Planning Commission Staff Report

DATE: June 11, 2014

SUBJECT: ROBERT W. MINER FOR A CONDITIONAL USE PERMIT AND ARCHITECTURAL REVIEW OF A PROPOSED 150,560-SQUARE FOOT WAREHOUSE DISTRIBUTION CENTER LOCATED ON APPROXIMATELY 22.61 ACRES OF VACANT LAND AT 411 WEST GARNET AVENUE, ZONE M-1-P (CASE 5.1307 CUP / 3.3688 MAJ).

SITE PLAN
SCALE: 1"=60'-0"

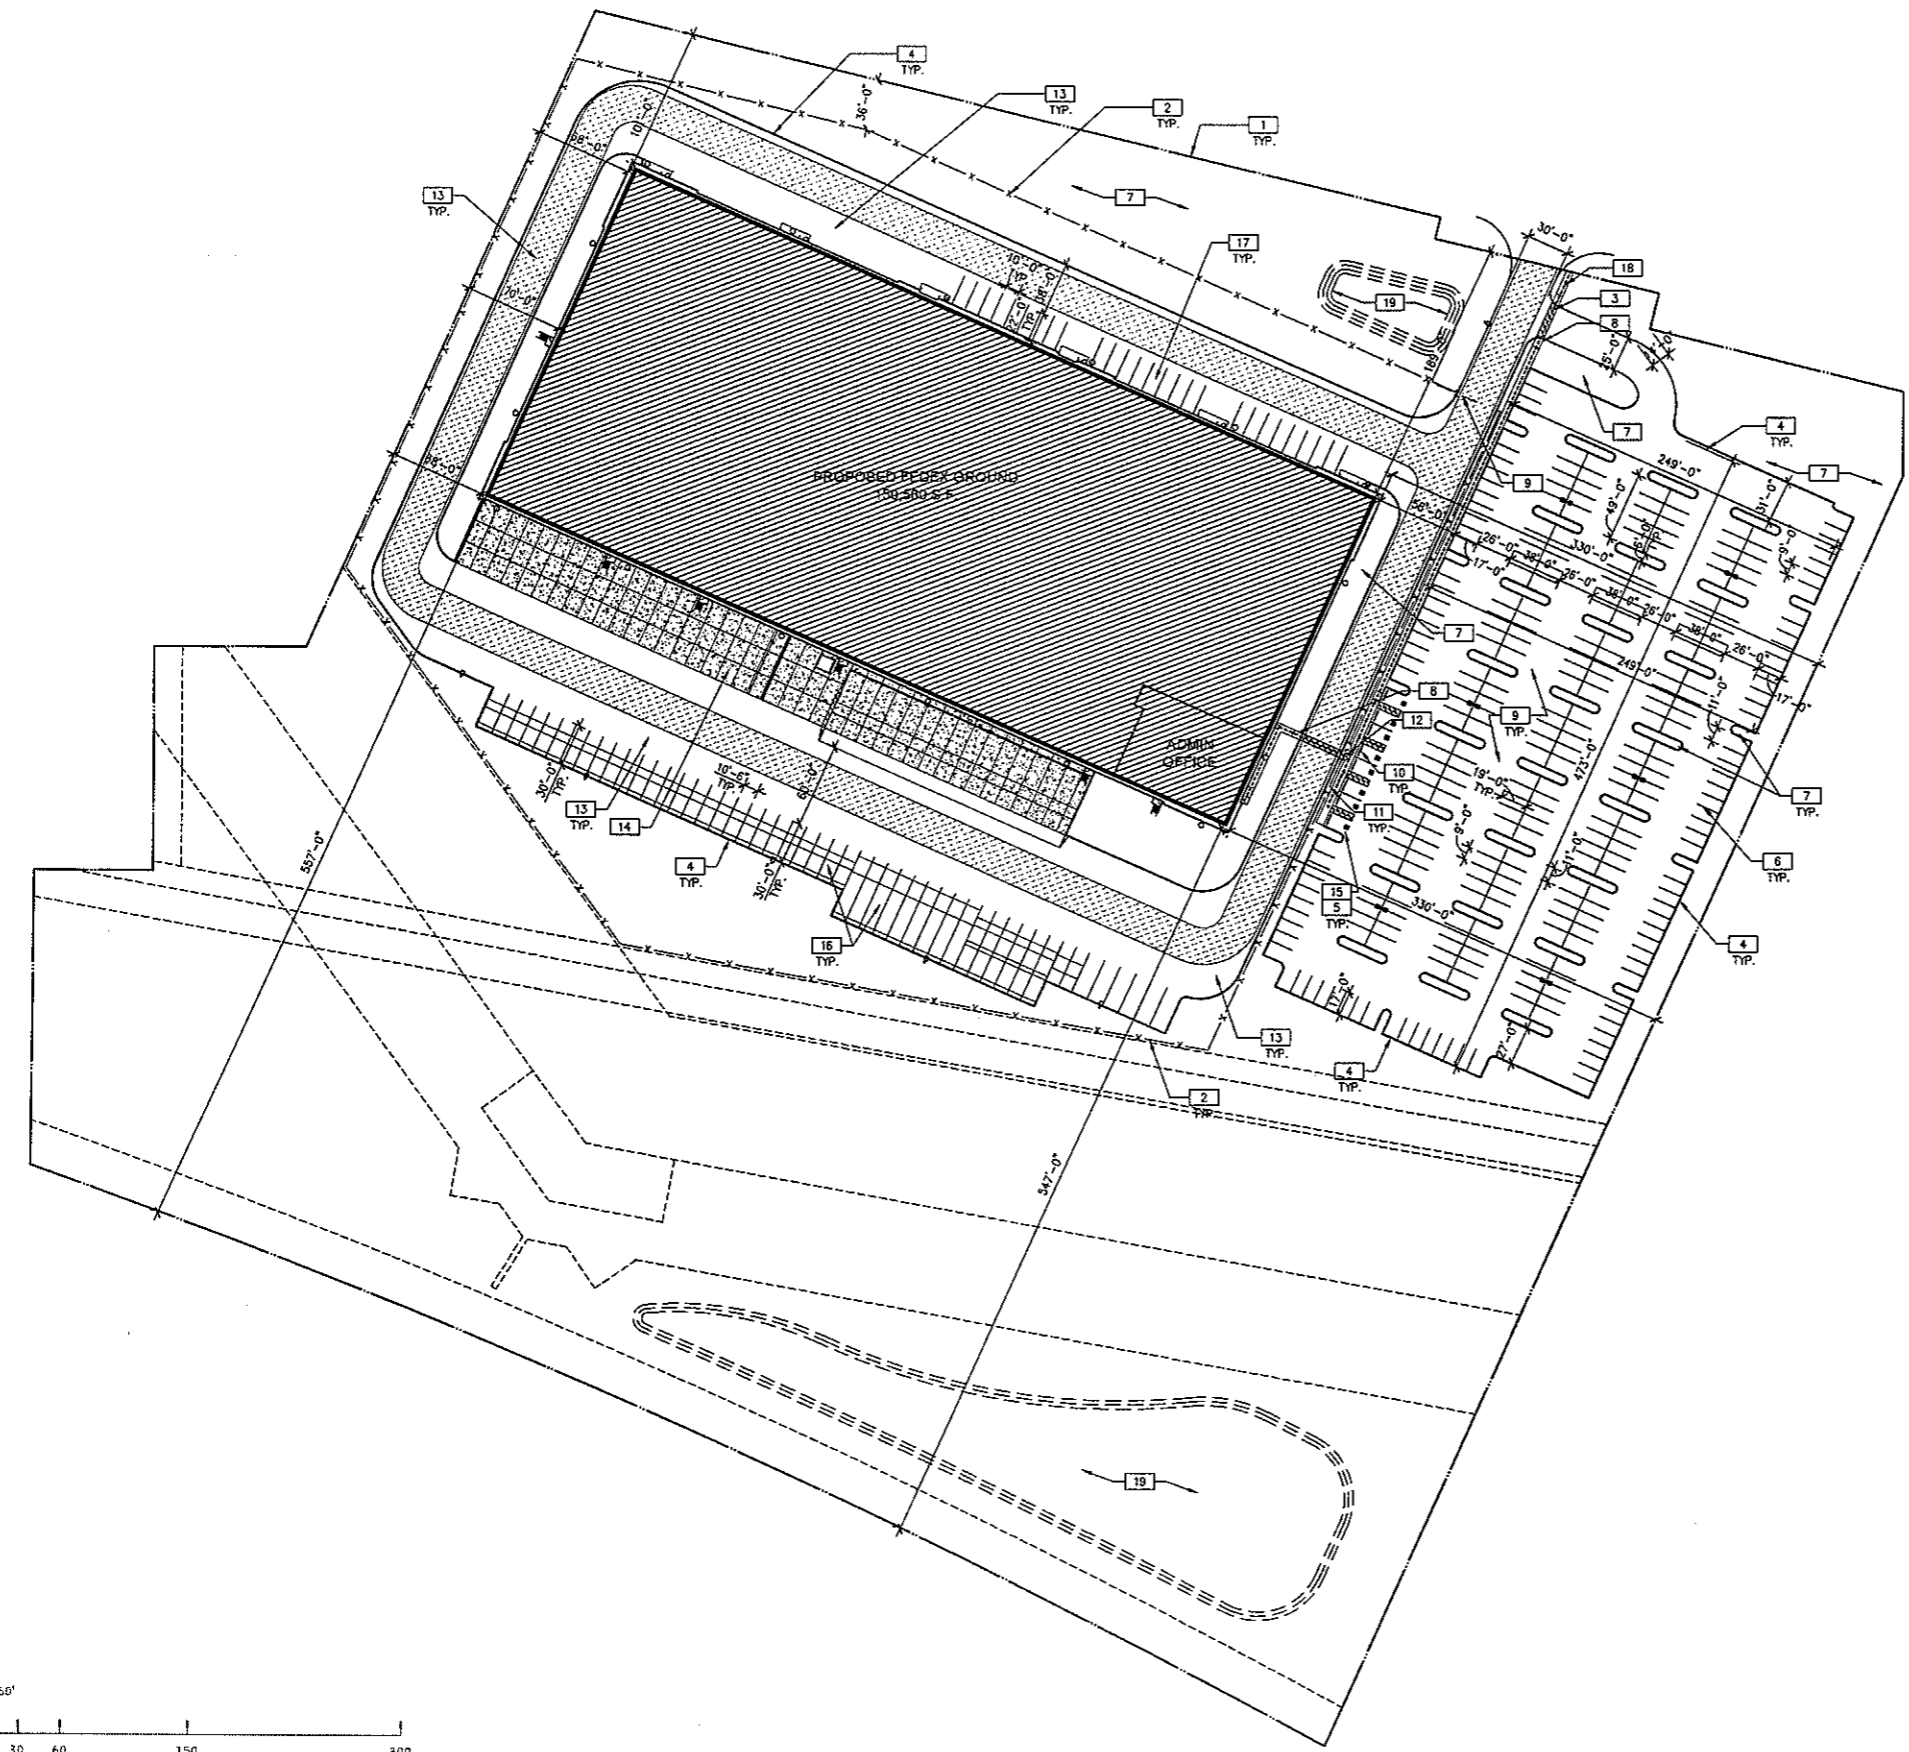
3/10/2014	The AAC recommended conditional approval: <ul style="list-style-type: none"> • Beta fence not chain link, no black color but rather complement perimeter • All trees to be 24" box • Consider sustainability methods including photovoltaic • Color of each exterior door to match the color of its adjacent wall
-----------	---

KEVIN KIERNAN, APPLICANT, said he was available to answer questions. He said the chain link is shown behind the landscaping but he would do beta fence with sharp top.

COMMITTEE MEMBER HIRSCHBEIN commented that the building is fine; better colors. He had a question regarding the beta fencing and prefers covered parking with solar panels.

SHEET TITLE
 LANDSCAPE & SHADE PLAN
 SHEET NUMBER
L1.01
 .01 OF 03 SHEETS

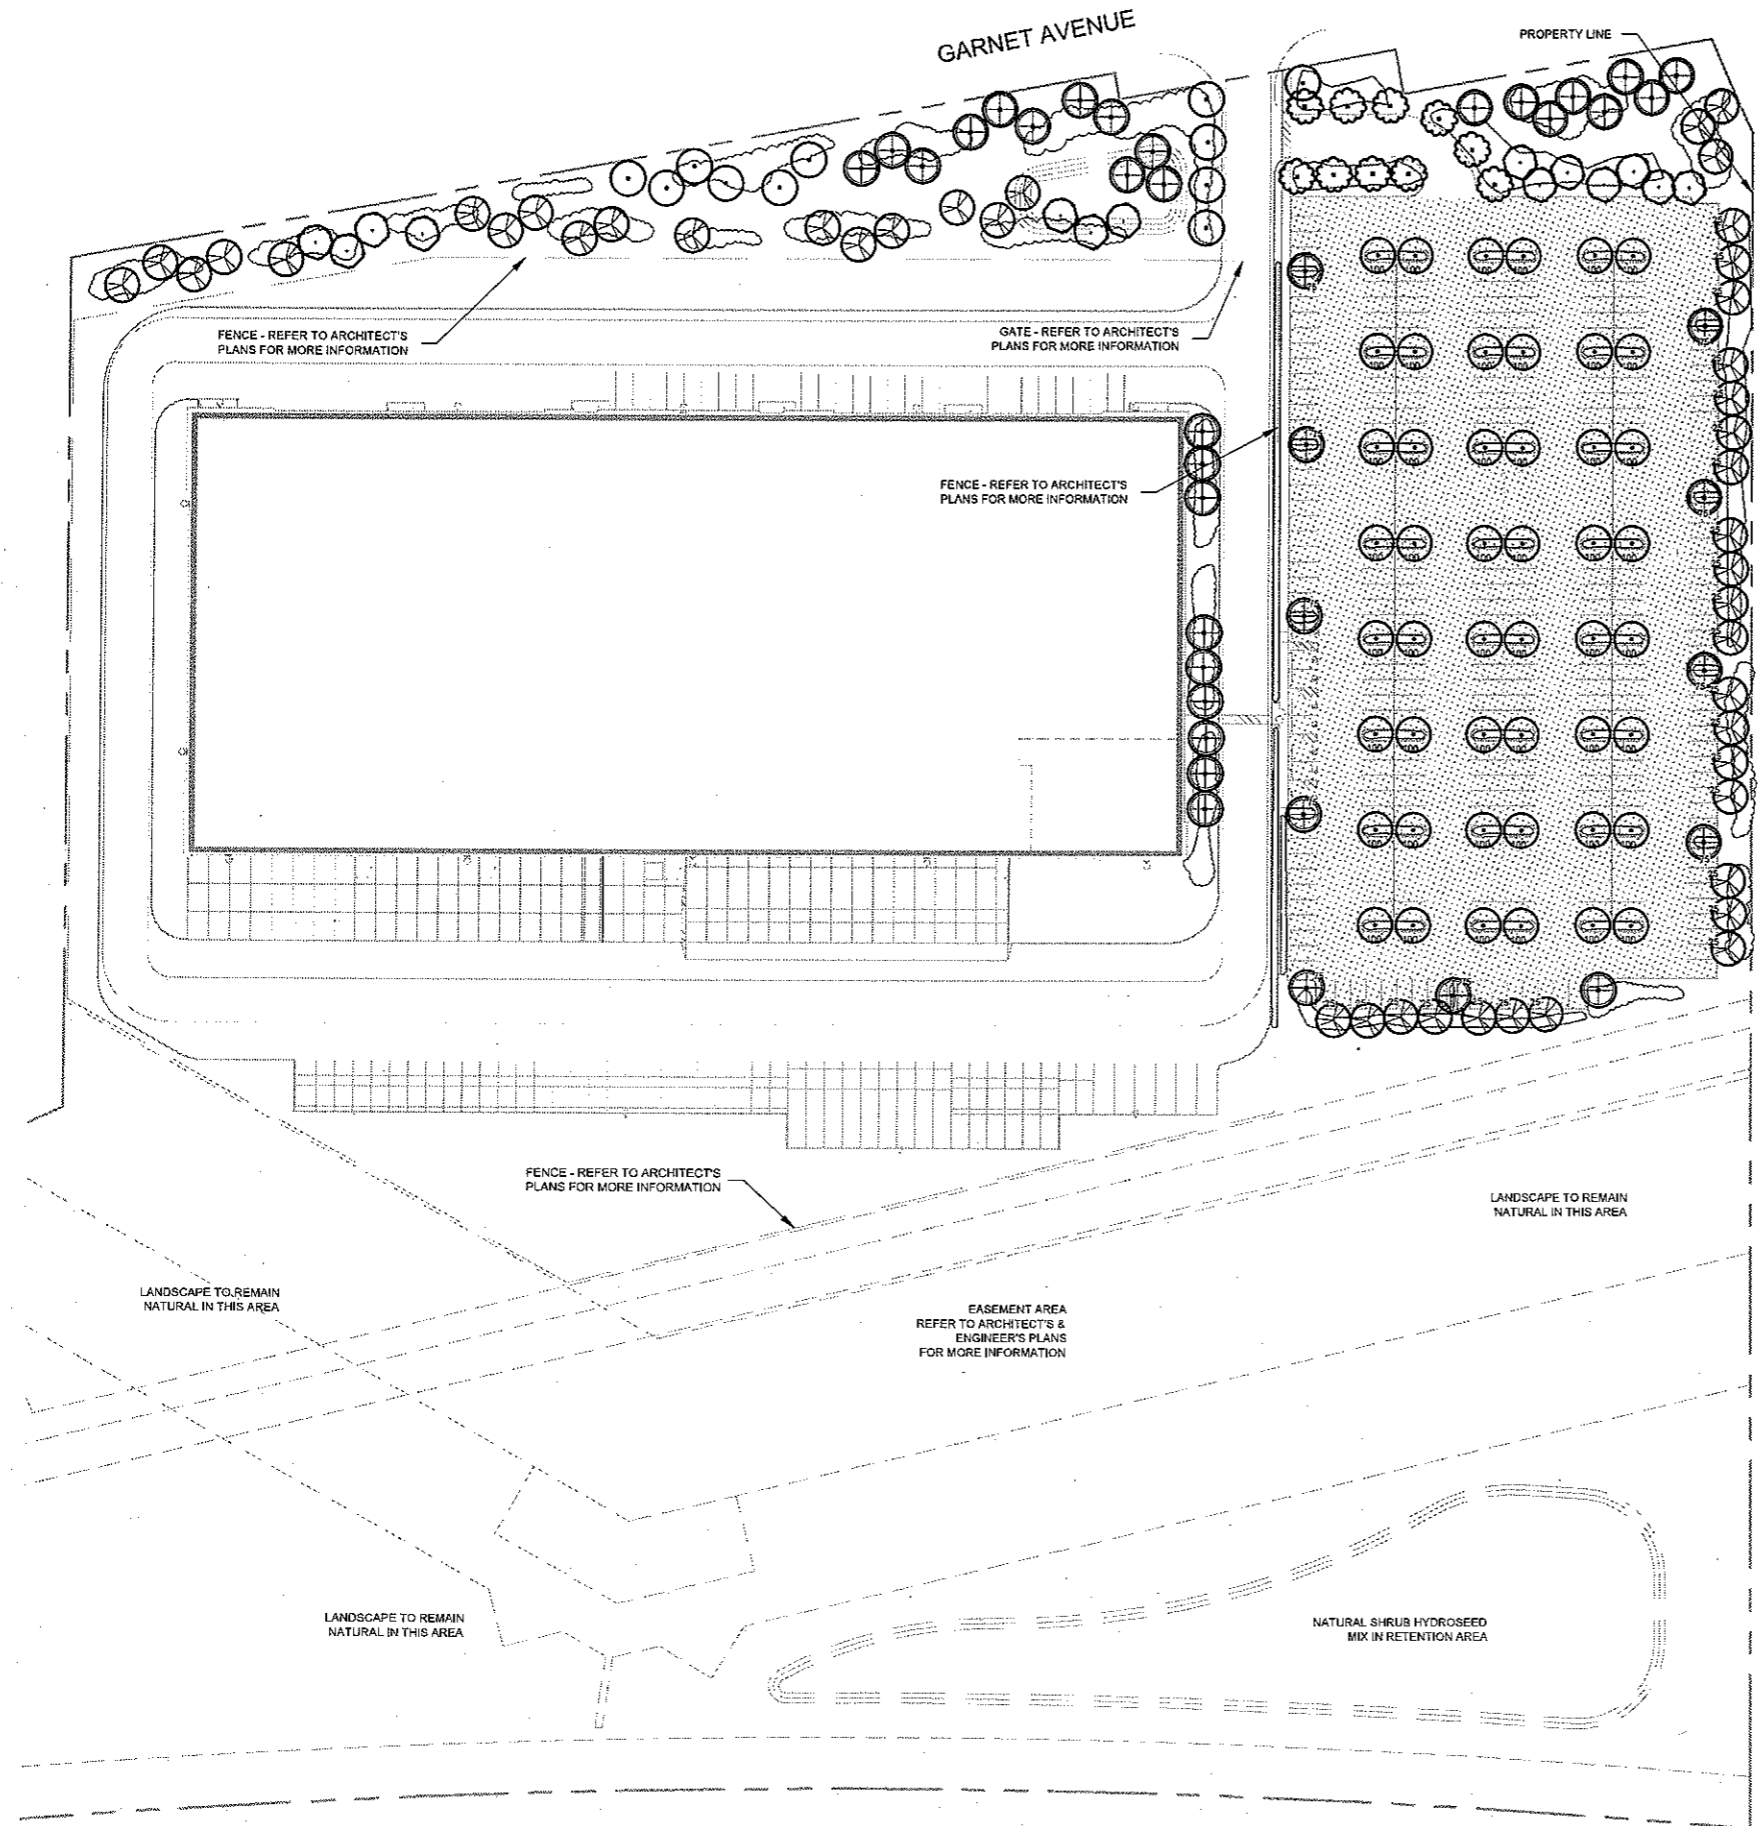
COMMITTEE MEMBER PURNEL agrees with Fredricks that trees may not live in, reflected heat and wind; and are too small. One gallon plants are too small also. Desert landscaping shown is good but is not the best. He suggested minimizing diversification of plants. No plantings shown on the south.
